GROUP <b>BOD</b>	MODEL <b>2019MY Soul (PS) Soul EV (PSEV)</b>
	NUMBER <b>187</b>	DATE <b>December 2018</b>
<b>TECHNICAL SERVICE BULLETIN</b>		
<b>SUBJECT: COMBINATION TSB / SERVICE ACTION: BULKHEAD SEALANT APPLICATION (SA362)</b>

COMBINATION TSB / SERVICE ACTION: BULKHEAD  
SEALANT APPLICATION (SA362)

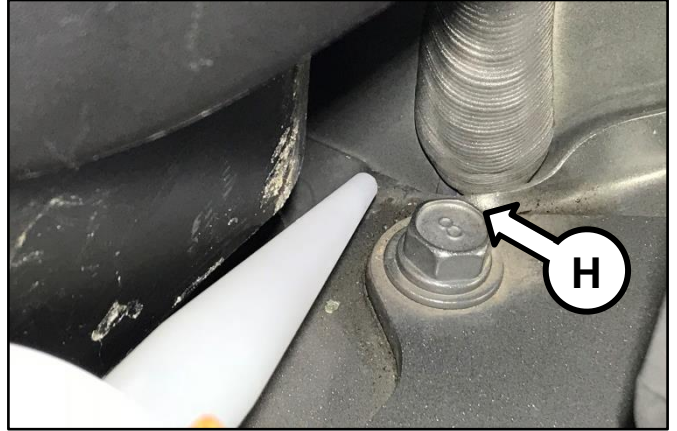
8. Clean the area and then apply a ¼ inch bead of the provided sealant (using a caulking gun) at the gap below the factory seam sealer (H), as shown. Ensure the gap is completely covered.

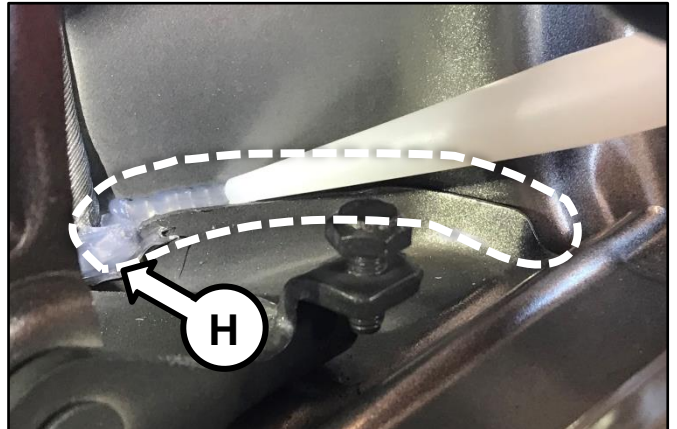
9. Continue the ¼ inch bead of the provided sealant at the gap between the factory seam sealer (H) and fender, as shown. Ensure the gap is completely covered.
